**AGENDA
OVERLAY DISTRICT BOARD
MARCH 5, 2019**

Re: Exterior Facade and Landscape Improvements for Zion Market Grocery Store @ 2405 S. Stemmons FWY (former Sears department store building)

17.5-4.(c), (1), e, 1
WINDOWS [GROUND FLOOR] Northeast Facade:
WINDOWS ARE ADDED AS MUCH AS POSSIBLE TO WORK WITH INSIDE LAYOUT

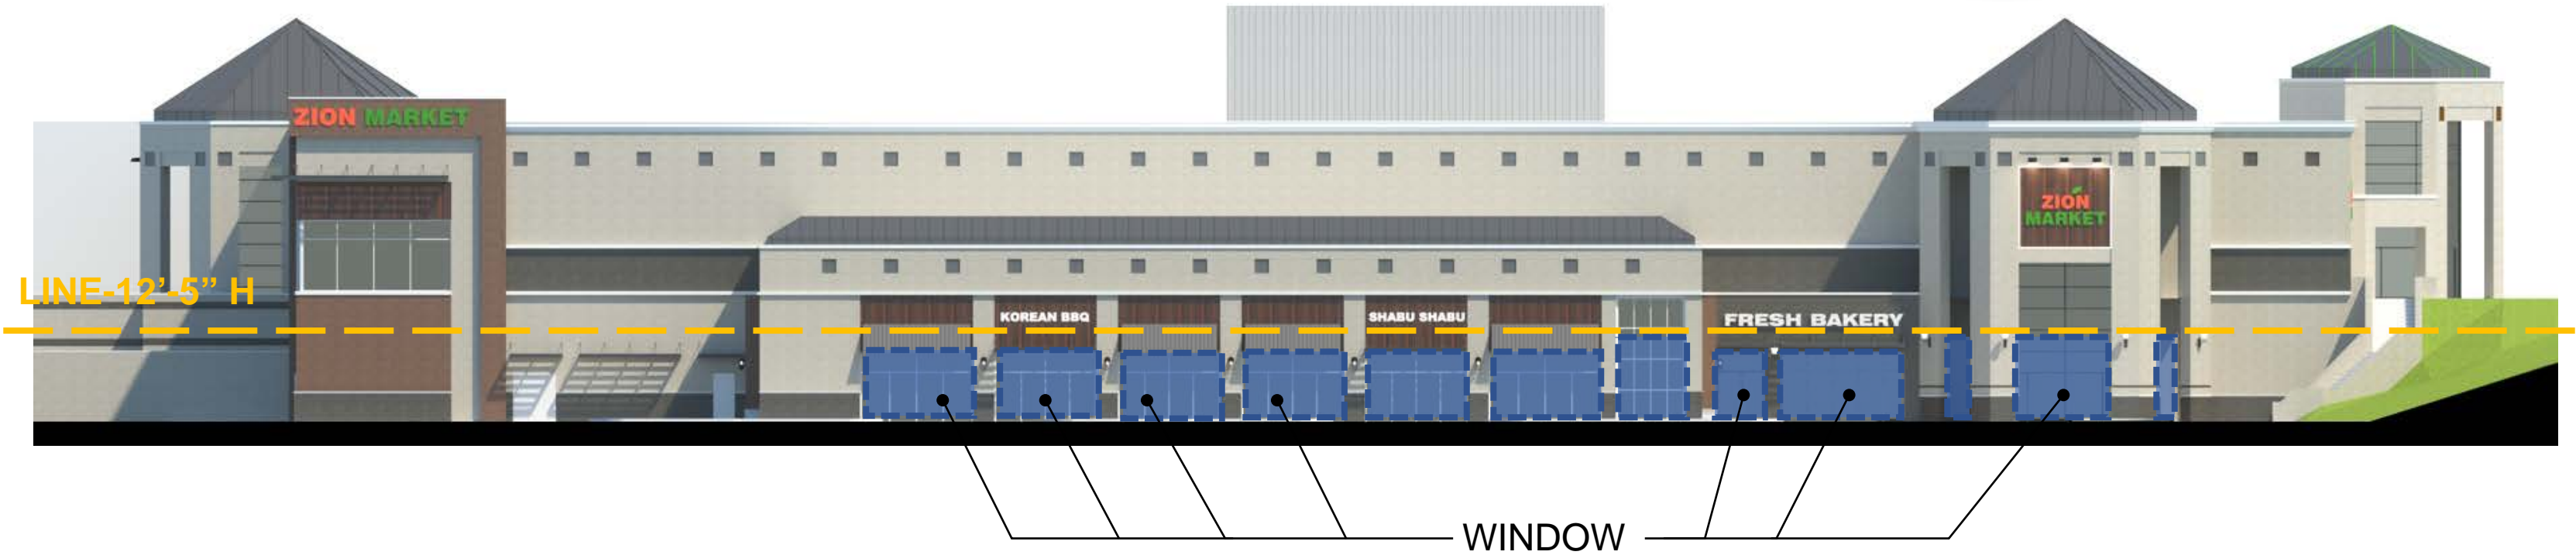
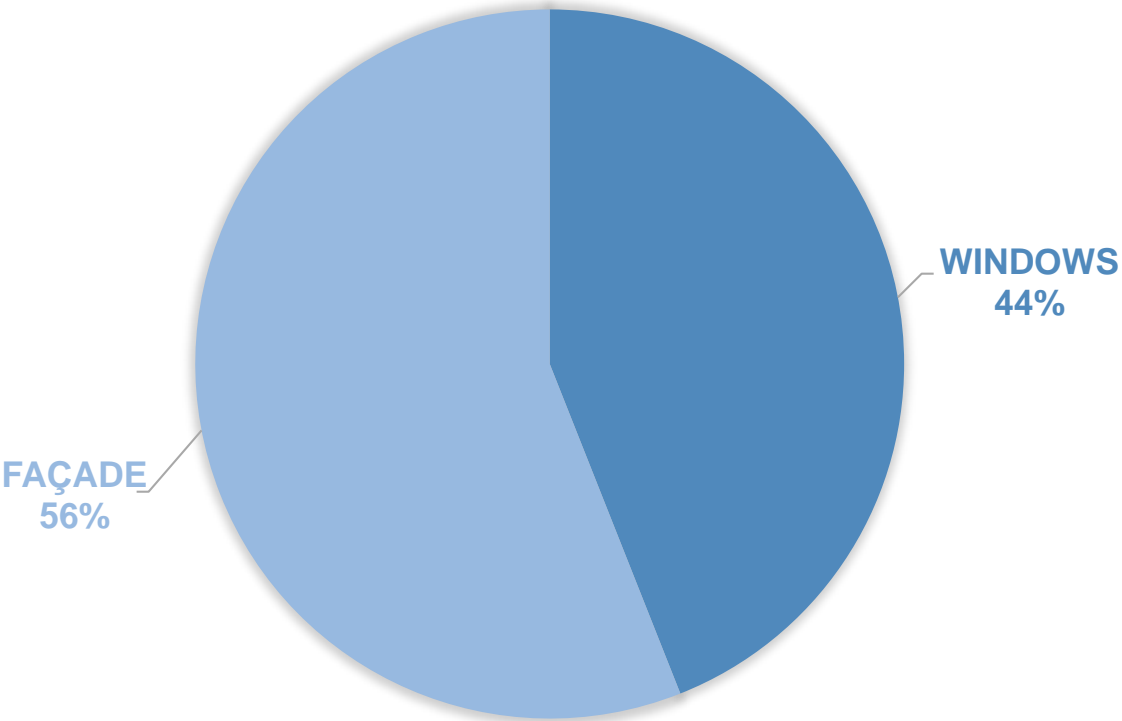
- (c), (1), e, 1 & 3 requires 60 percent minimum of the ground floor façade area be comprised of windows for buildings with retail and 25 percent minimum of the upper floor façade area. Due to conflict with existing conditions inside (exit stairs, fire sprinkler room, stocking room), we were able to provide 44 percent for the ground floor and 10 percent for the second floor.

17.5-4.(c), (4), a
AWNING & SIDEWALK Northeast Facade:

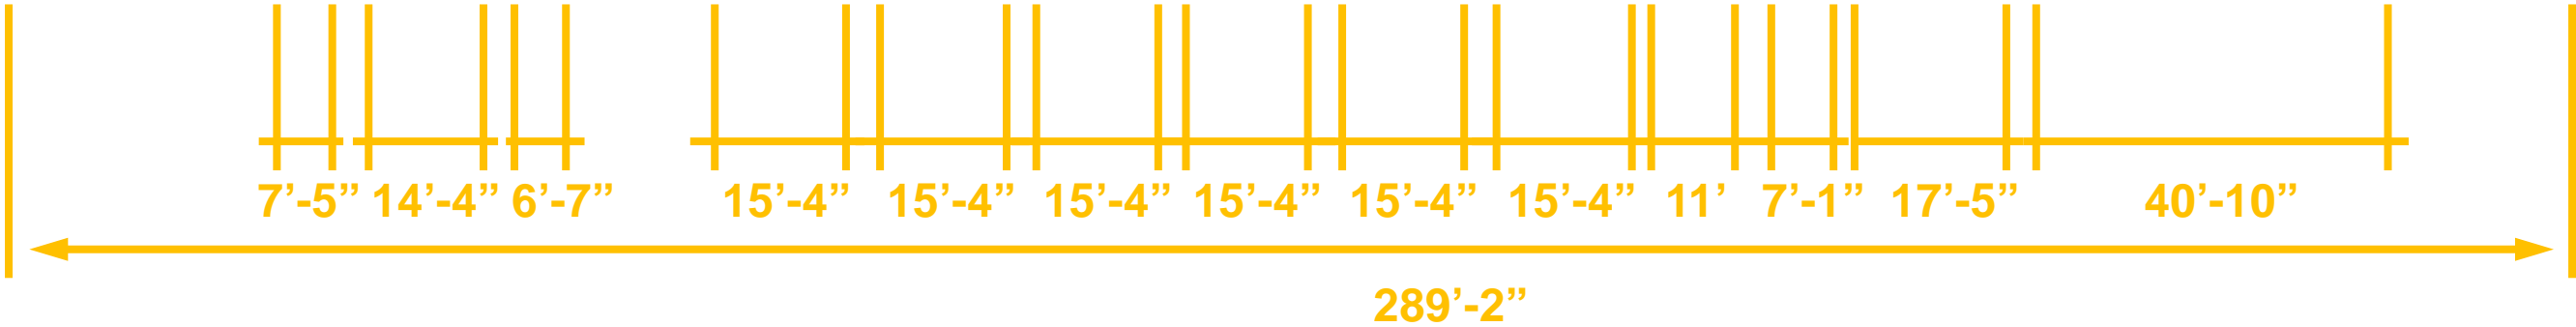
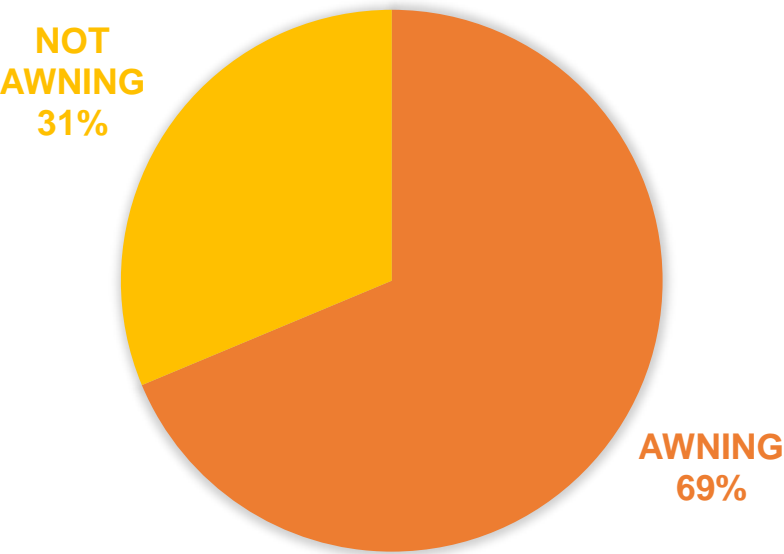
- (c), (4), a requires awnings or canopies a minimum of 75 percent along the building's sidewalk frontage. Our design provides 69 percent. Note that we provide awnings or canopies at all doors and windows.

17.5-4.(c), (4), a
AWNING & SIDEWALK Southeast facade:

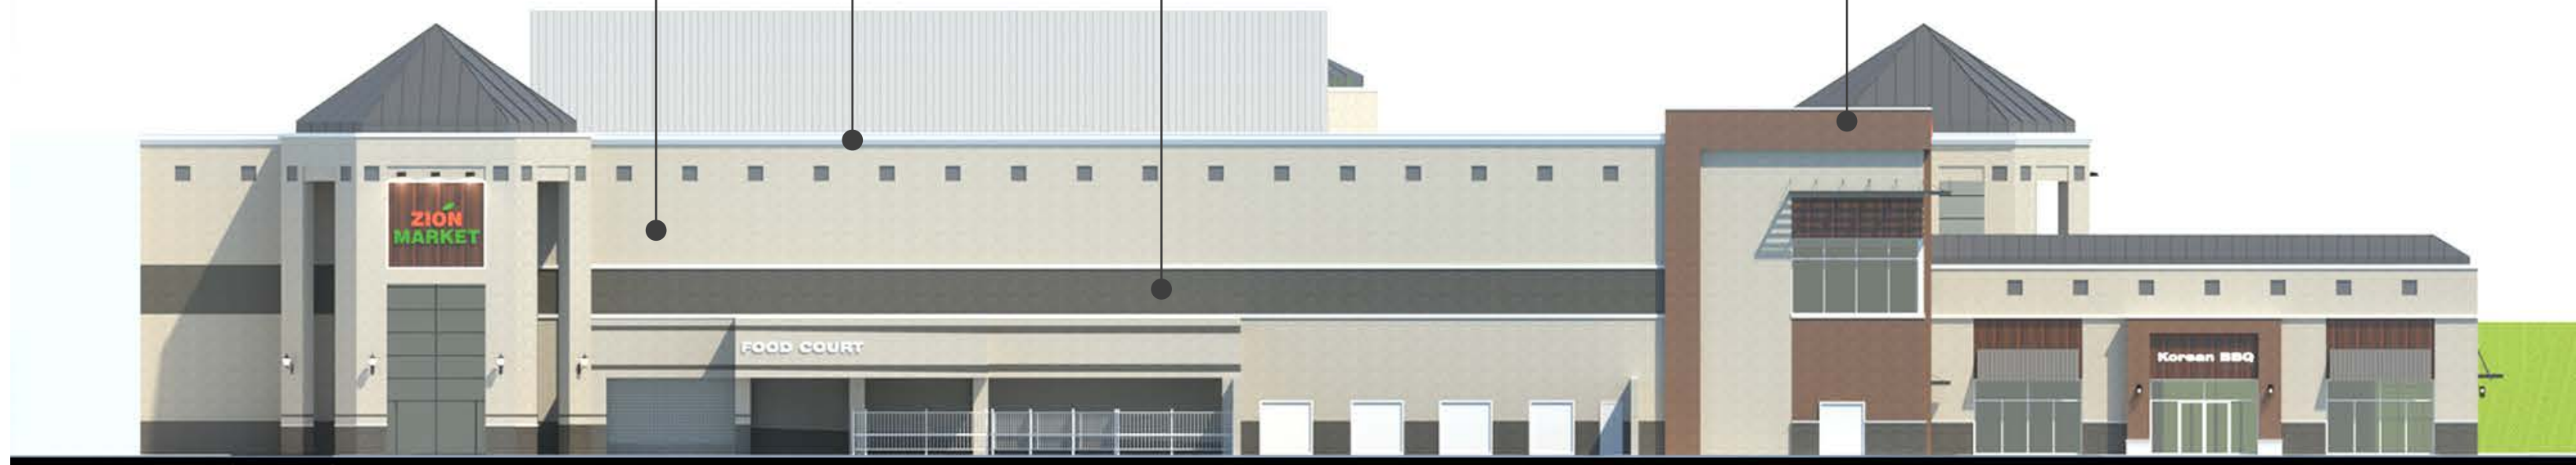
- (c), (4), a requires awnings or canopies a minimum of 75 percent along the building's sidewalk frontage. Our design provides 68 percent. Note that we provide awnings or canopies at all doors and windows.
